City of Newton, Massachusetts

PUBLIC HEARING MEMORANDUM

SUBJECT: Petition #317-20, for SPECIAL PERMIT/SITE PLAN APPROVAL to extend a

68 Chestnut Street

Proposed Site Plan

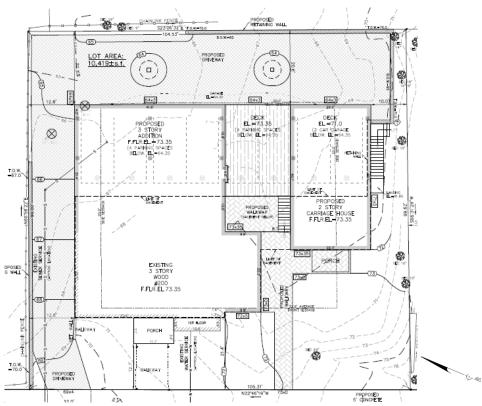
The petitioner is proposing a three-story addition to the rear of the structure as well as a two-story detached structure. The addition will further extend the nonconforming side setback on the northern boundary. Due to the slope of the lot, the nonconforming building height is increasing from 39.99 feet to 40.36 feet, but the principal roofline is not changing. The principal structure, as well as the proposed carriage house, will be 20 feet from the rear lot line, the maximum allowed. The two structures contain 9,350 square feet, resulting in a floor area ratio of .9, where 1.5 is the maximum allowed for a three-story structure in the BU-1 zoning district.

The proposed two-story carriage house will be set farther back from the principal structure but will be connected via a deck. The carriage house is 25 feet tall and is set back ten feet from the southern property line. The petitioners are proposing retaining walls along the northern, eastern and southern, property lines. The proposed retaining wall within the rear setback measures five feet in height, requiring a special permit and the retaining wall proposed along the southern boundary within the side setback measures six feet in height, also requiring a special permit. This relief was not included in the special permit application, as such, the petition needs to be docketed, noticed, and advertised again to include this relief.
